PP Ref: J005109

Re: Submission – SSD-69773460 Residential & Commercial (Mixed use) 35-37 Dwyer Street and 372-374 Mann Street, North Gosford

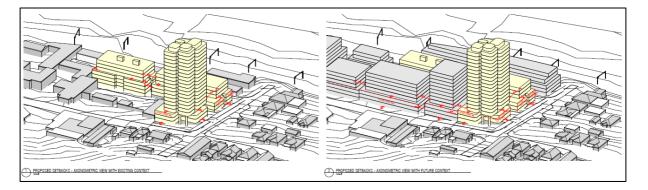
As evidenced by the Community Engagement Table and subsequent Engagement Report provided as Appendix D and Appendix DD, a large number of community members have raised the same issues being:

- Traffic impacts
- On-street parking impacts
- Noise impacts
- Excessive height

- Visual impact
- Population density and increased load on infrastructure and services
- Incompatibility with and inconsideration of character of the area
- Crime and safety impacts
- Pollution and environmental impacts due to construction and ongoing traffic activity
- Psychological impacts and social impacts

While responses to community concerns have been provided, they have been done so retrospectively and reactively rather than adopting a proactive approach by having community members considered when preparing the development design. As a result, the proposal appears as a gross overdevelopment that makes no consideration for the many adverse impacts it will have on the locality.
